SECTION 2: IR SUPPORTING DOCUMENTS

239 & 241 Boundary St, Coolangatta

**Information Request Response
Copy of Council's Information Request**

Response to Information Request

Figure 1: Comparable high-rises in proximity of the site (adapted from Plus Architecture)

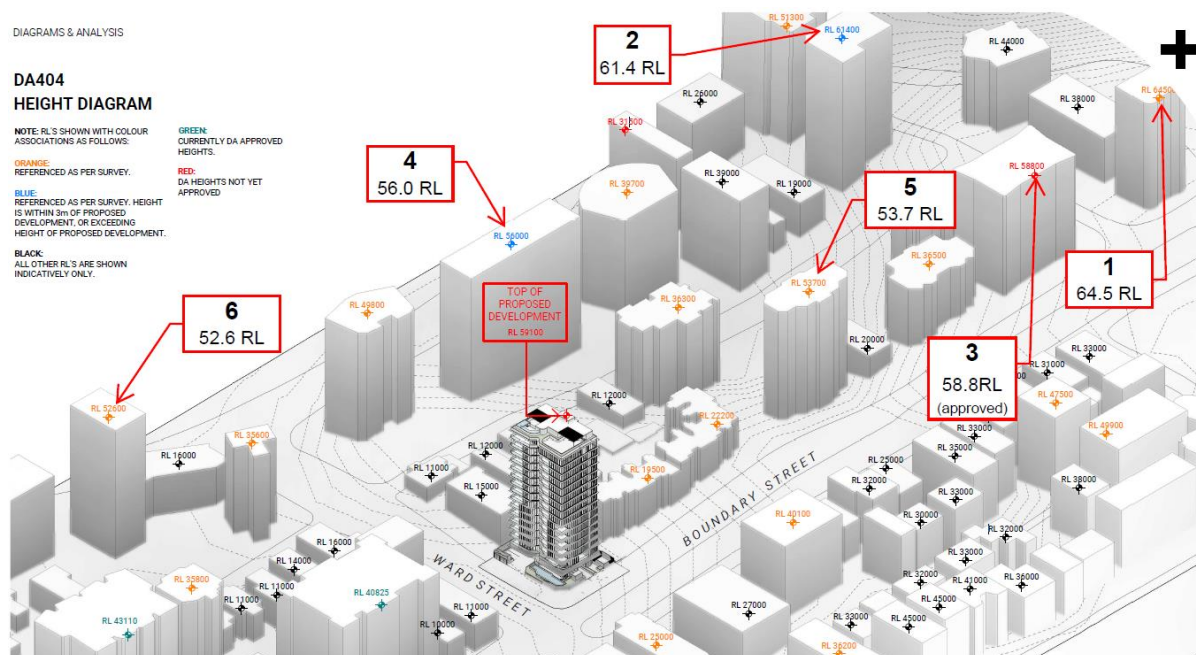
Officers are concerned with the height of the building shown in its context given a height 50% over the building height overlay map is proposed. In order to enable officers to adequately assess the building height against Specific outcome 3.3.2.1(9) of the strategic framework, the applicant is requested to provide the following:

- (a) A detailed assessment of the surrounding building heights particularly demonstrating the maximum RL of each building. It is preferred that drawings/diagrams are provided showing these heights in relation to the proposed building height;
- (b) Photo montages showing the proposed building in the context of the surrounding area and including the massing of any surrounding approved buildings that have not been constructed.

RESPONSE: The Amended Development Plans (**Section 3 – IR Plans**) now includes additional Building Height Analysis Plans in response to this item. DA403 and DA404 Height Diagrams include surveyed heights of key existing comparable buildings in the area, indicative heights of other buildings, and the heights of approved (but not yet constructed) buildings, and buildings currently under assessment. We note that there are several buildings of similar height to the proposal (59.1m RL) in the area as shown below and overleaf.

1. 64.5m RL – 275 Boundary Street (existing)
2. 61.4m RL – 3 Eden Avenue (existing)
59.1m RL – 239 & 241 Boundary Street (Subject proposal)
3. 58.8m RL – 271 Boundary Street (approved)
4. 56.0m RL – 184-190 Marine Parade (existing)
5. 53.7m RL – 255-261 Boundary Street (existing)
6. 52.6m RL – 166-170 Marine Parade (existing)

The proposed building has a maximum height of 59.1m RL (56.7m above natural ground level) which is less than existing buildings located at 275 Boundary Street and 3 Eden Avenue; and is comparable to several other existing buildings in the area. It is only marginally higher than the proposal approved at 271 Boundary Street.

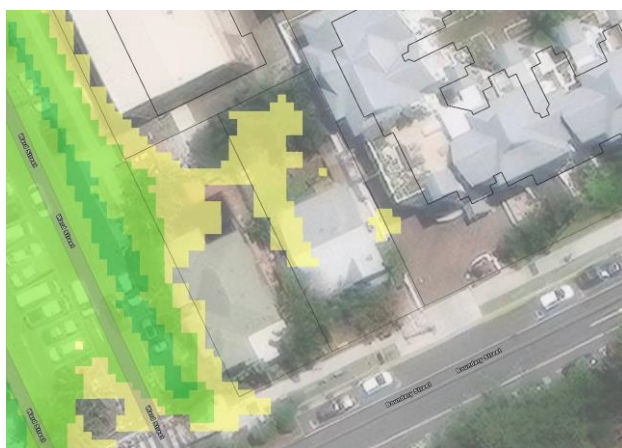
- (c) *The Developed Flood Storage Layout Plan depicted in Figure 1 below, does not make it clear how the highlighted area would contribute to obtain the necessary flood storage capacity in a 1% AEP event. Also demonstrate how the floodwaters will stop entering the basement after filling to a depth of 400mm or above (up to 600 mm) in order to achieve requisite flood storage capacity. The applicant is requested to address and amend the previously submitted architectural plans by clearly showing the passage of flood water to basement or other designated area without impacting the transition of vehicle movement in and out of basement.*

- (d) *The Developed Flood Storage Layout Plan depicted in Figure 1 below does not consider reasonable grades and changes of grade to ensure vehicles can safely drive through this area for the long periods when flooding does not occur.*

- (e) *The Developed Flood Storage Layout Plan depicted in Figure 1 below appears to be in the wrong location. This should be positioned as far from the access ramp as possible so that cars in the unflooded area do not have to drive through floodwaters to exit the garage thereby placing themselves at risk.*

c) Please refer to the revised flood code response reporting. Plans detailing how flood waters will enter the basement and how basement flood water depths will be managed are provided within.

d) The intent of this RFI item is unclear, the flood storage calculations consider the basement carpark grades provided by the architect at 1:20 maximum grades.
